ZV(R)2023-0124-0127

Zoning Variances

16453 NW 21 Street Pembroke Pines FL 33028

Summary

Sketch Analysis:

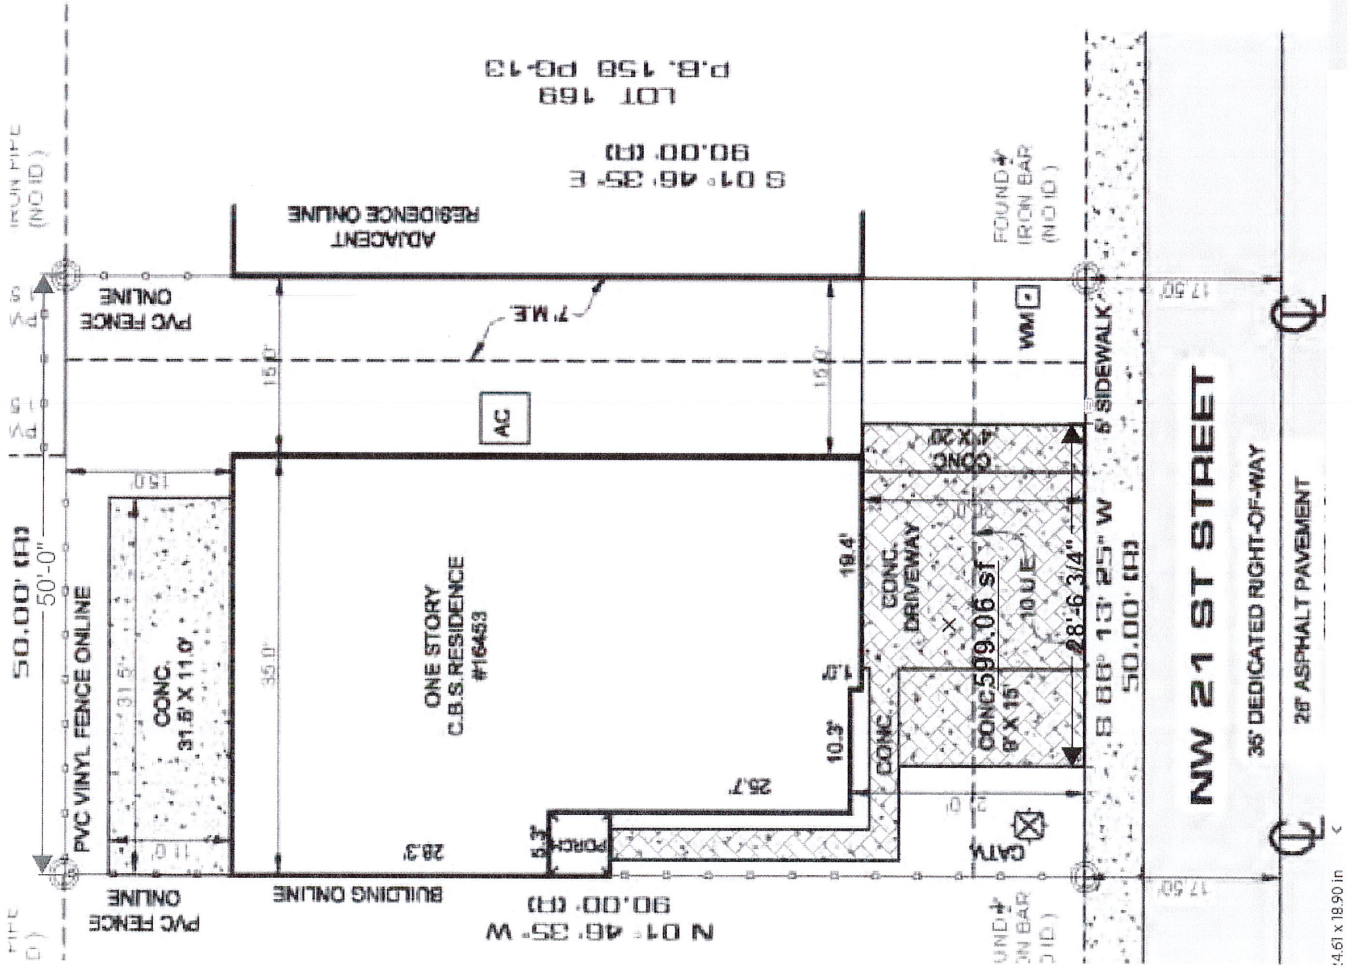
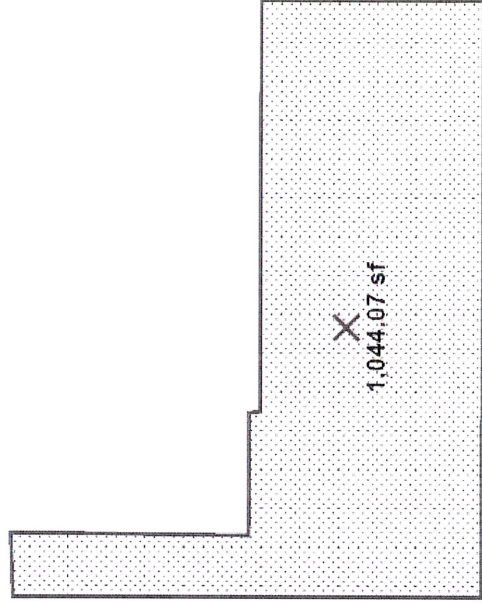
- Front Lot Area is 1,045 SF
- Allowed FLC is 40% or 418 S.F.
- Allowed driveway width is 40% or 20 L.F.F.
- Existing FLC is 600 S.F. or 57.4 (58%)
- Existing driveway width is 28'-7" L.F.F. or 57.1 % (58%)
- Existing rear patio shall be 5' away from side and rear property lines.
